TENNESSEE VALLEY AUTHORITY

RAPID SULFUR METER LICENSE NO. 41-08165-12 REQUEST FOR AMENDMENT NO. 1

This amendment request is to document several phone conversations with Mr. Earl Wright discussing control No. 81-81, and is pursuant to the guidelines set forth in the Code of Federal Regulations, Title 10, Part 30, 30.38. We request that our by-product material license No. 41-08165-12 be amended as indicated below.

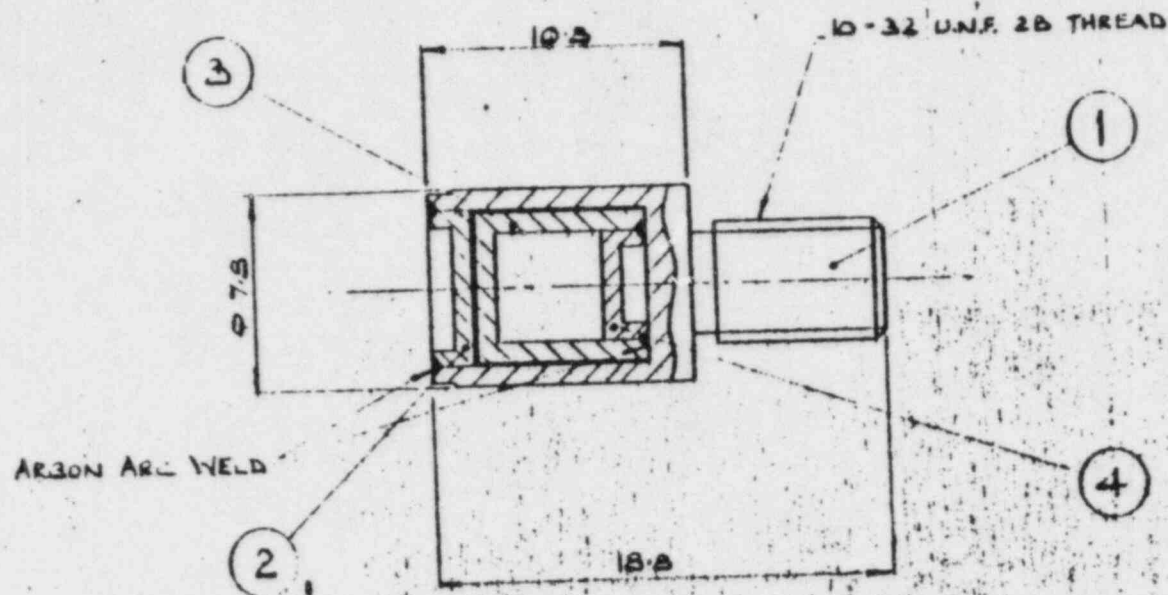
Item 7, of the license should be changed to an Amersham sealed source as shown in drawing No. 3A 11154/S.

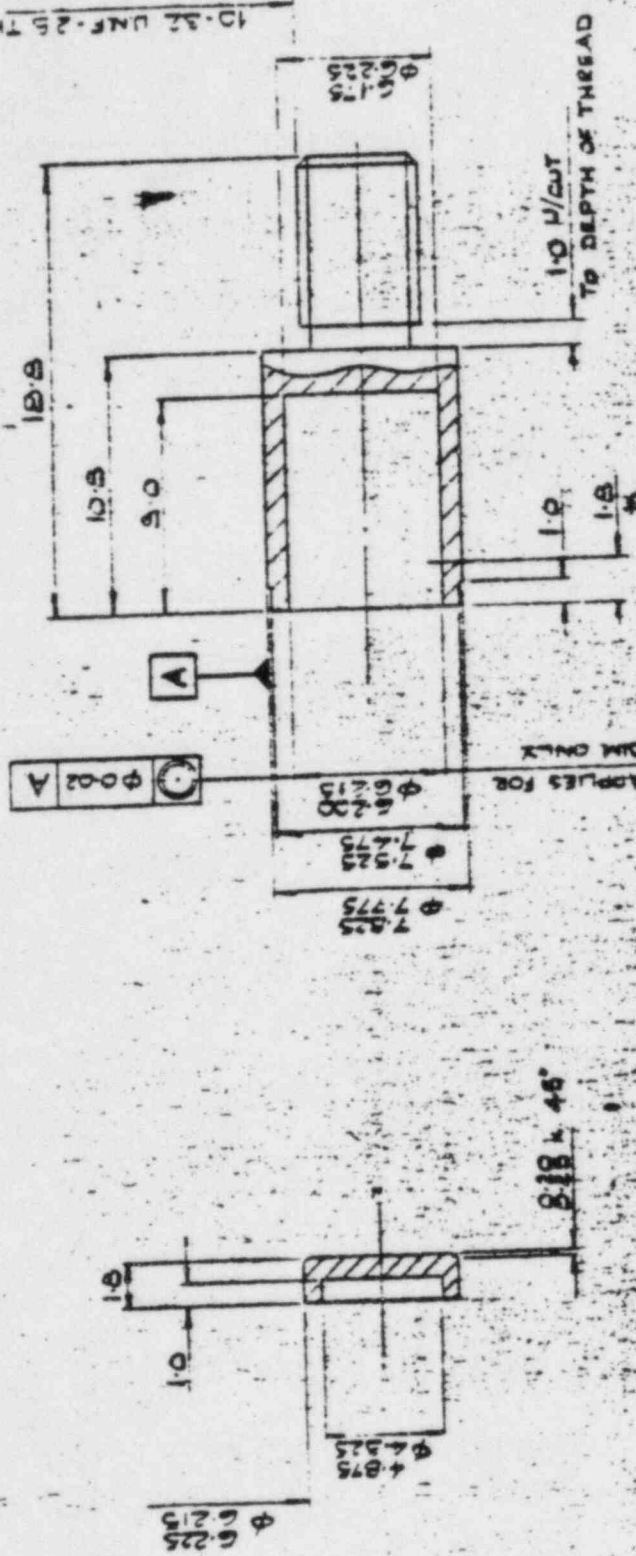
The enclosed supporting drawings (No. 3A11153/S and ARC 10623/S) show the outer (XN247) and inner encapsulations. The inner encapsulation is made of zircalloy (XN142). It is special-form approved as detailed in certificate No. GB/210/S (attached).
